## HILL VALLEY - PHASE 2B

CITY PROJECT NO. 15860  
CONTRACT NO. 9680

#### REVISION 1 - 04/29/26

#### REVISION 2 - 05/28/26

UTILITIES PLAN & PROFILE - ENCHANTMENT RD  
 HILL VALLEY - PHASE 2B  
 M:\DESIGN\Projects\15860\CAD\Sewers\15860SWR-PipeNetwork.dwg

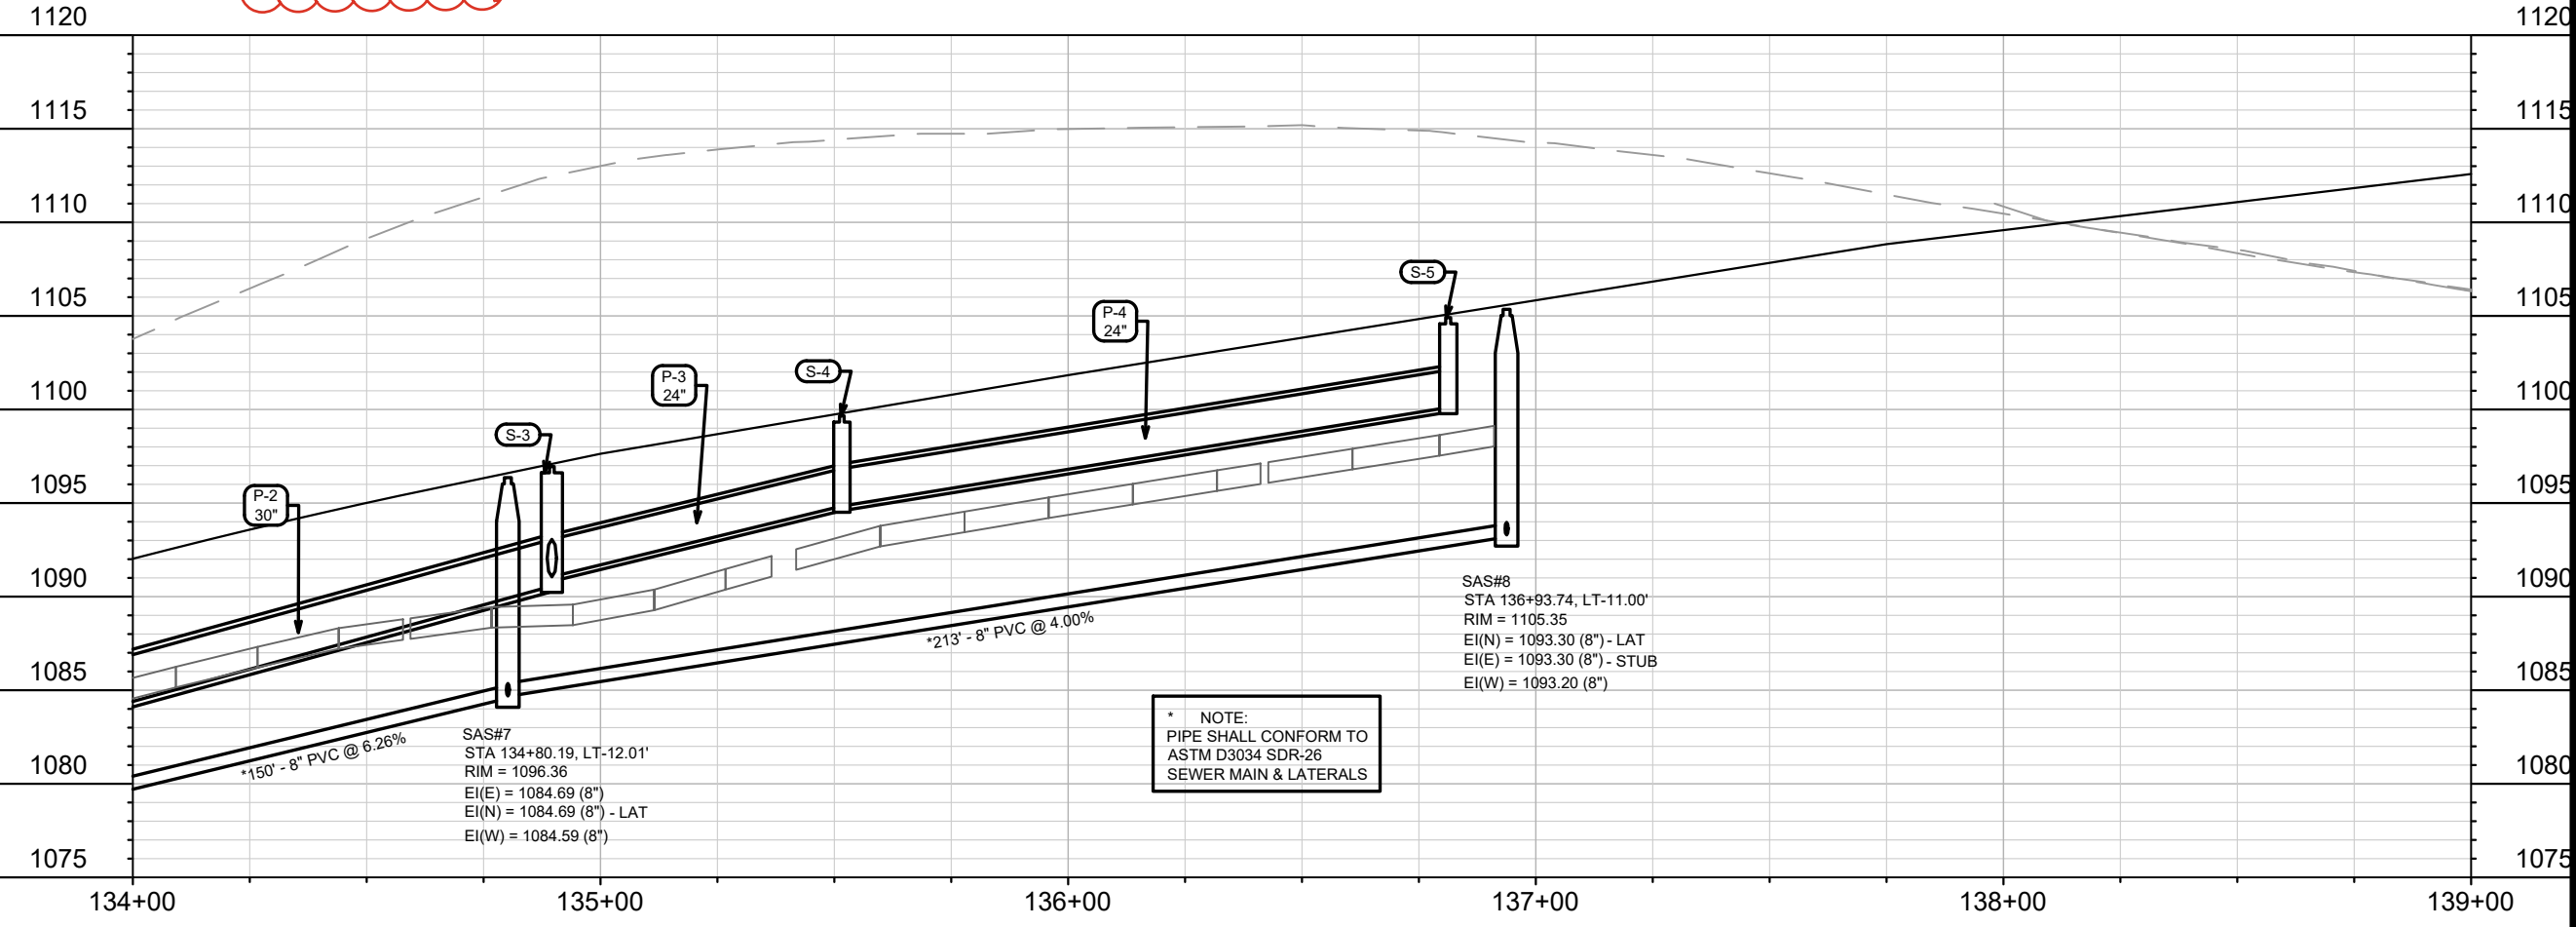
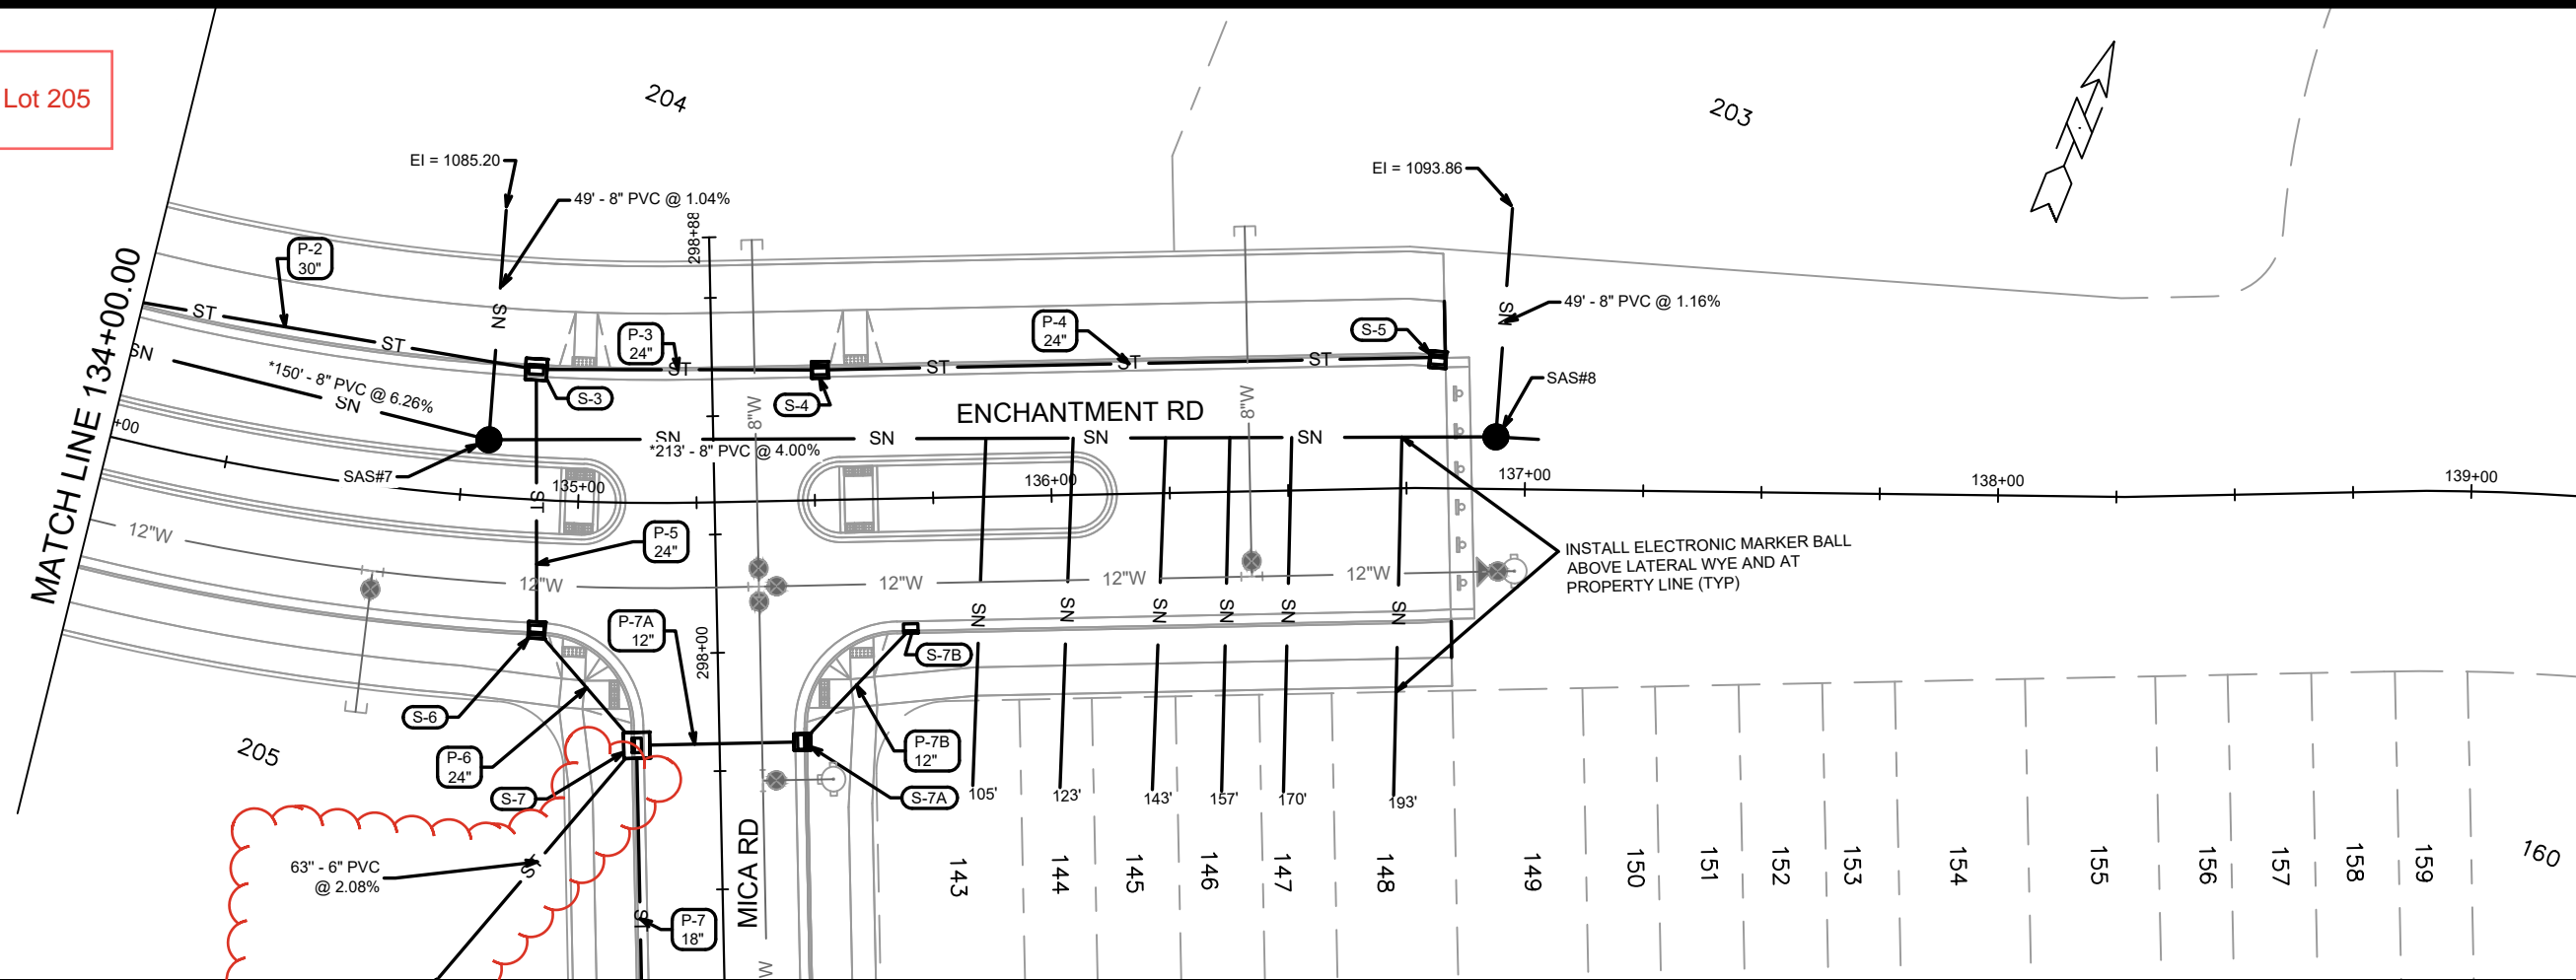
REVISED 5/28/2026 EEA  
 -Added pvt storm lateral to Lot 205

UTILITIES PLAN & PROFILE - MICA RD  
 HILL VALLEY - PHASE 2B  
 M:\DESIGN\Projects\15860\CAD\Severs\15860SWR-PipeNetwork.dwg

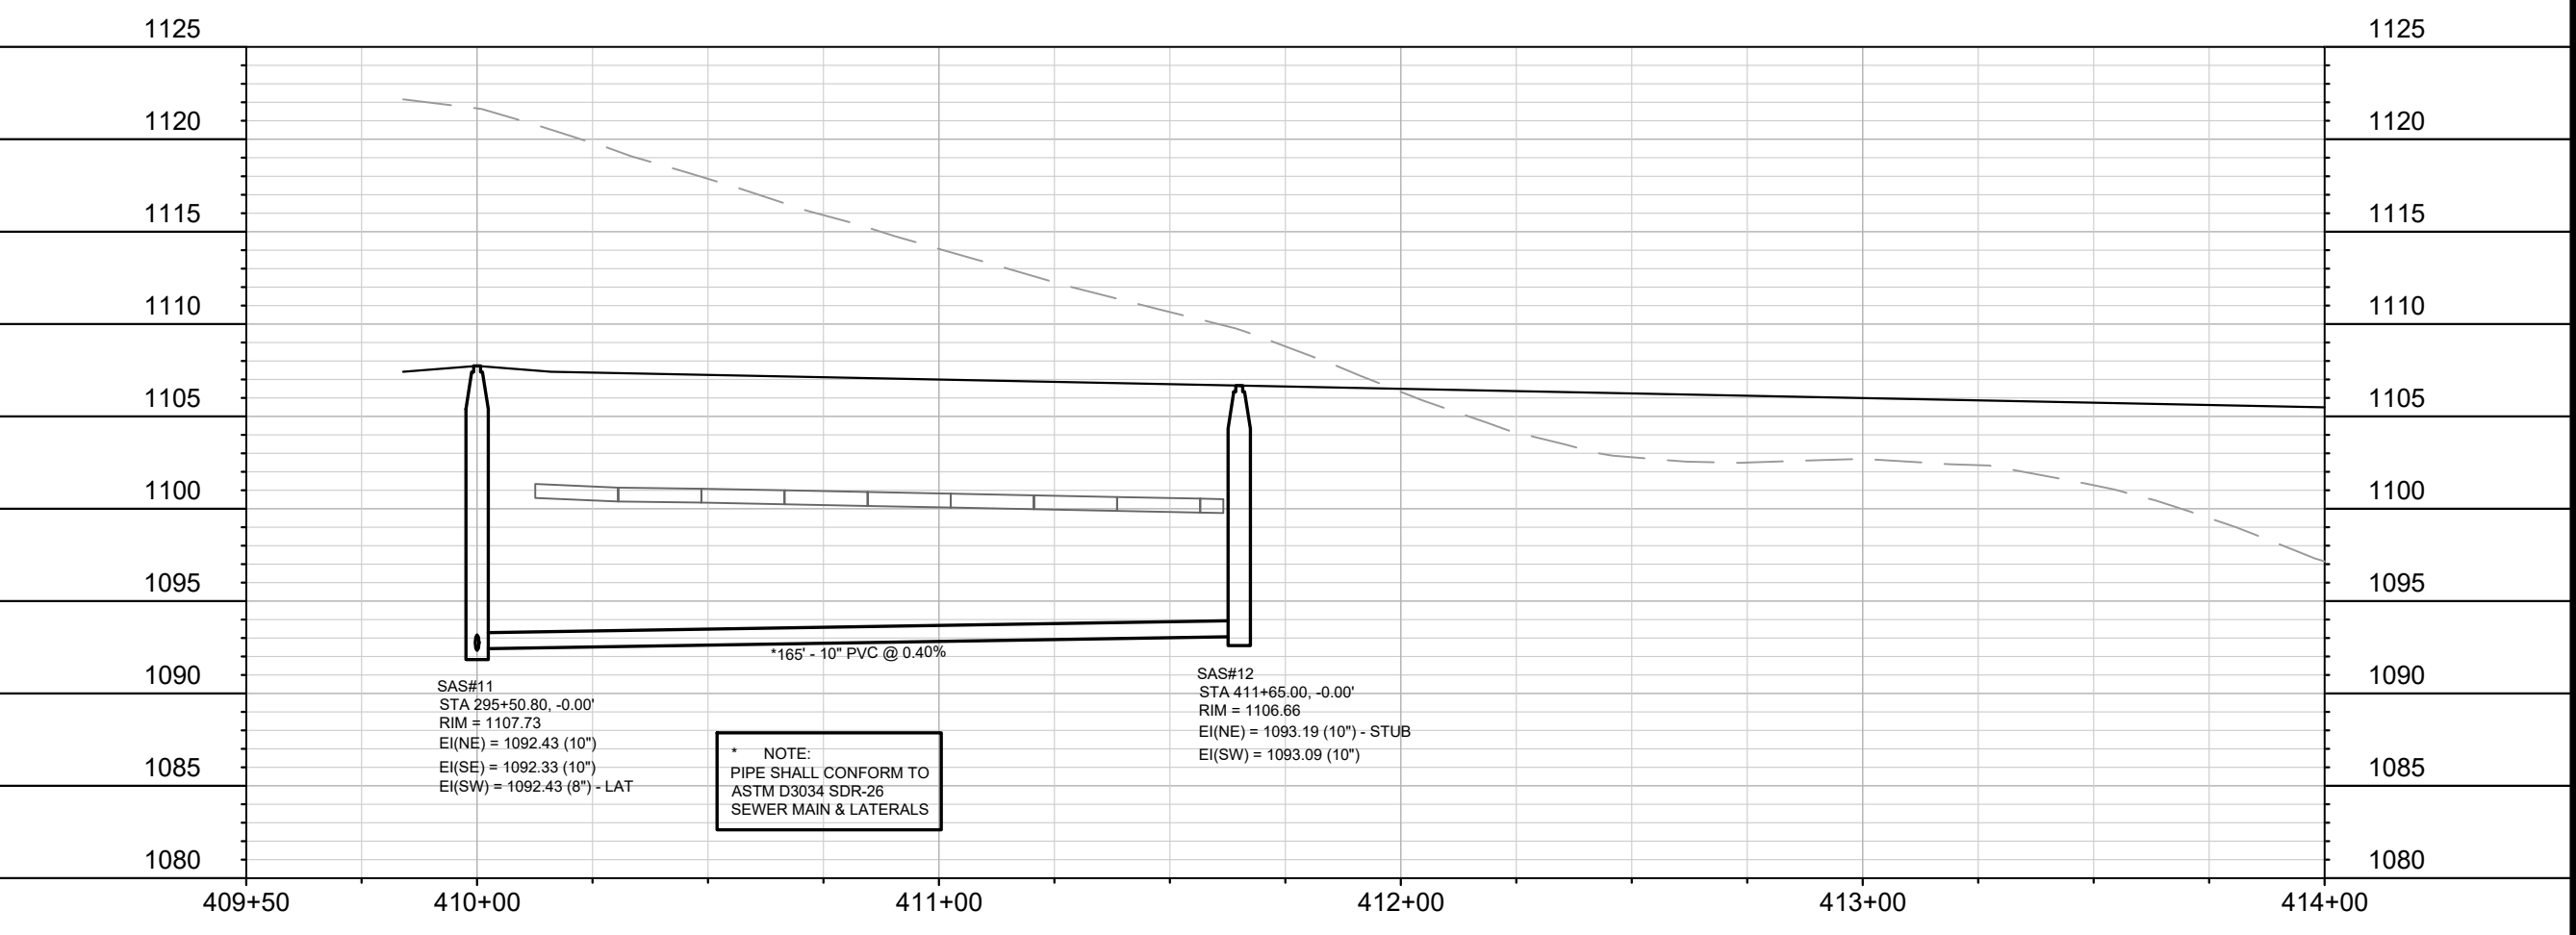
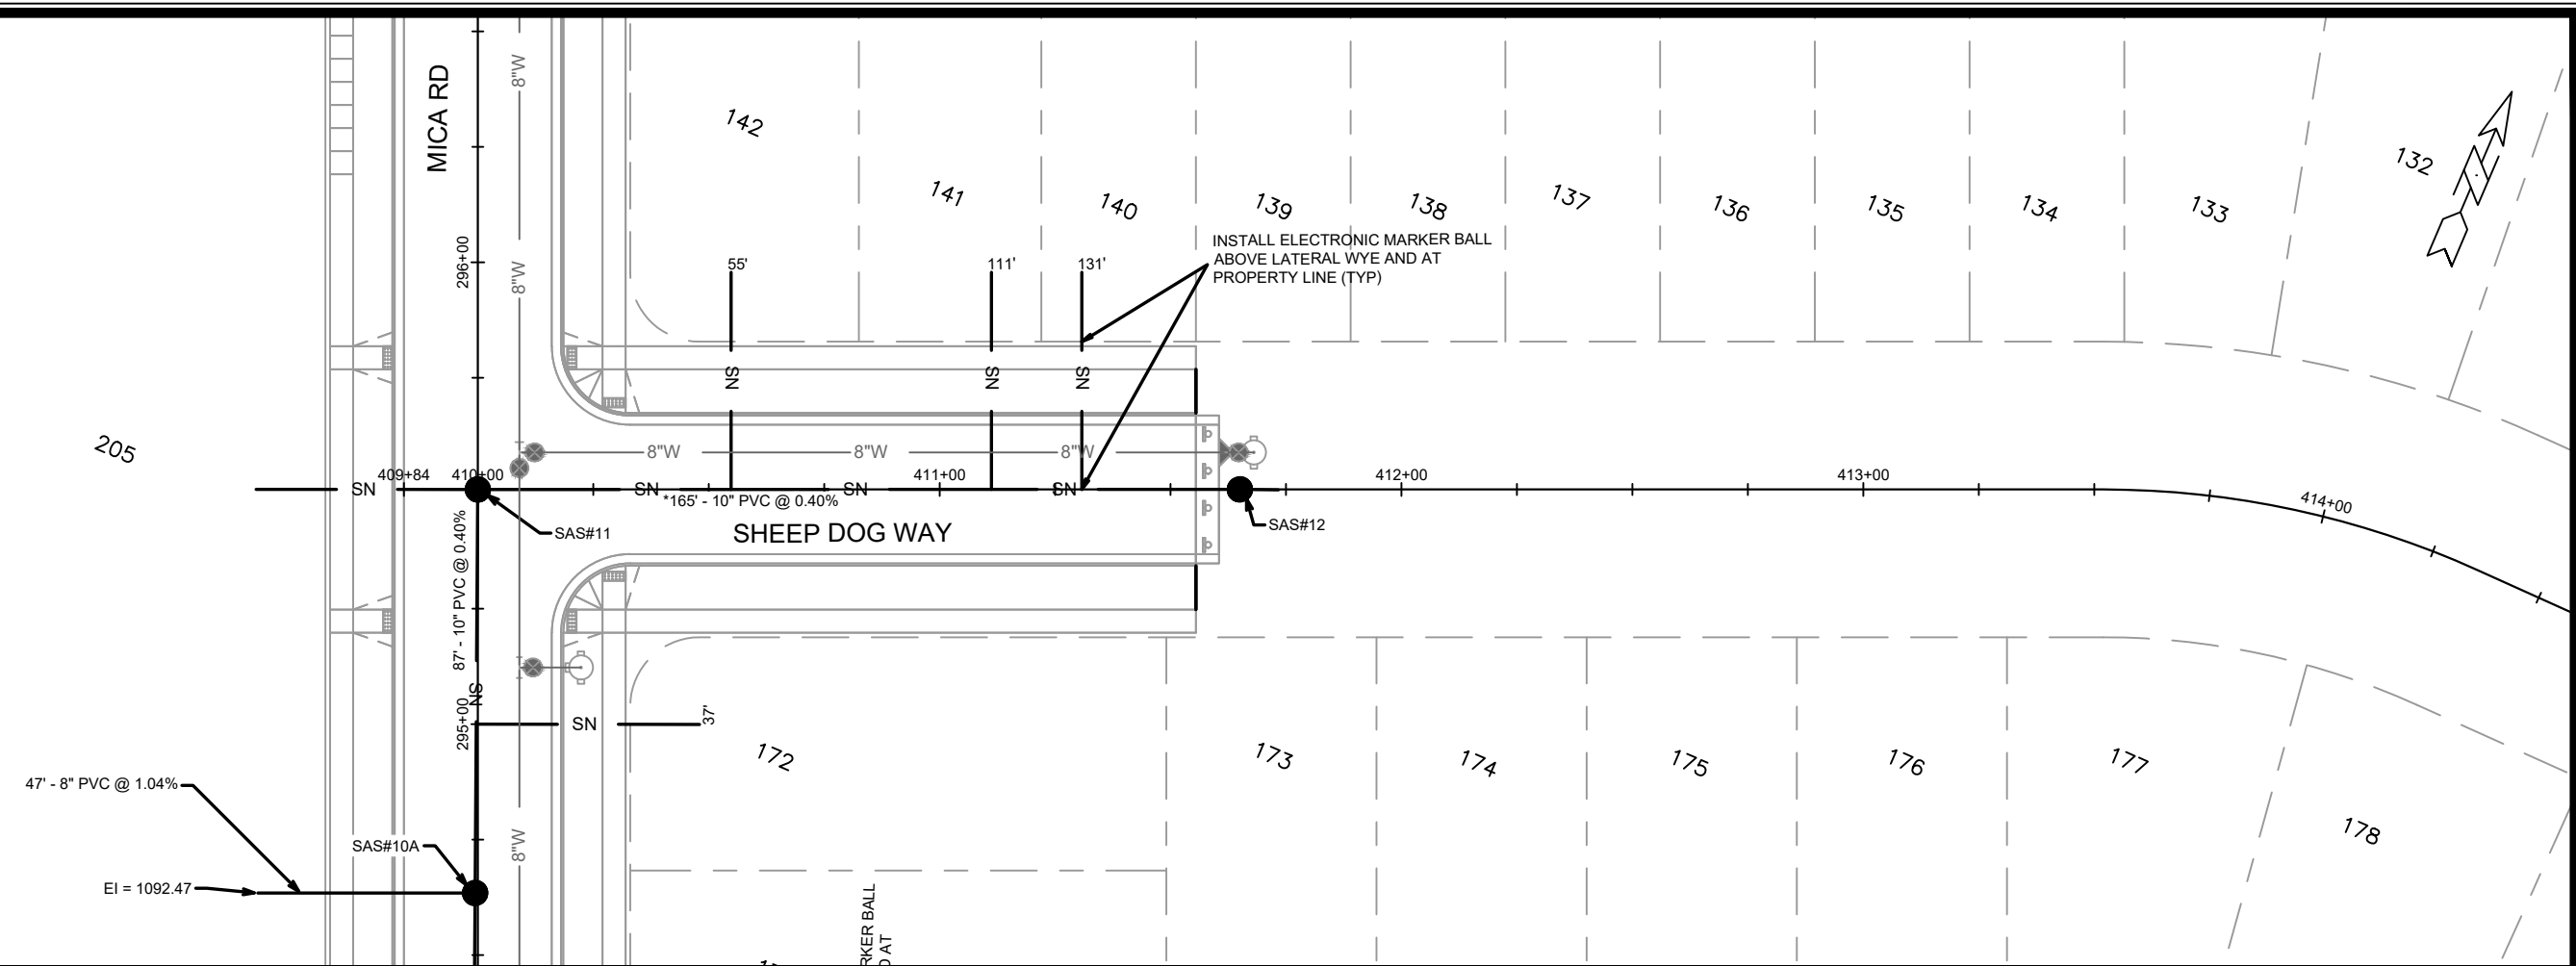
REVISED 5/28/2026 EEA  
 -Added pvt storm lateral to Lot 205
